Amendments to the Drawings

Remarks

Drawings

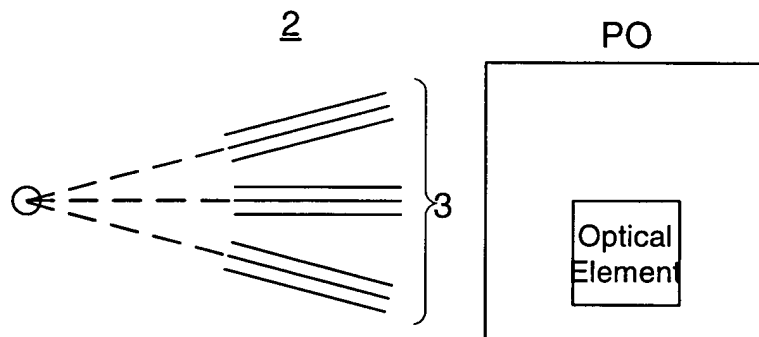
The drawings were objected to under 37 C.F.R. 1.83(a) for allegedly not showing every feature of the claimed invention. The Office Action indicated that the following features must be shown or the features canceled from the claims: (1) the processing organ; (2) the plurality of plates positioned substantially parallel to one another; (3) the lithographic apparatus and at least one optical element; and (4) plates positioned substantially orthogonally to another plate. Applicant traverses.

However, Applicant does not relinquish, for example, an embodiment of a filter having both a plurality of plates positioned substantially parallel in relation to one another and plates directed radially from the radiation source.

Solely to expedite prosecution, Applicant has amended the drawings as directed by the Office Action. In particular, Fig. 1 has been amended to show a processing organ PO, such as a lithographic apparatus having an optical element (e.g., a mirror), as described in at least col. 1, lines 11-29, and 42-45; and col. 3, line 54-col. 4, line 3. Fig. 4 has been newly added to show a plurality of plates positioned substantially parallel to one another, as described in at least col. 3, lines 23-30. Furthermore, the second drawing of Fig. 3, for example, shows one or more plates positioned substantially orthogonally to another plate. Accordingly, this objection should be withdrawn.

For example, the above illustration shows an embodiment having three groups of plates, wherein each group of plates has a plurality of plates positioned substantially parallel in relation to one another and each group of plates is directed radially from the radiation source. Of course, this embodiment also depicts plates directed away from the radiation source.
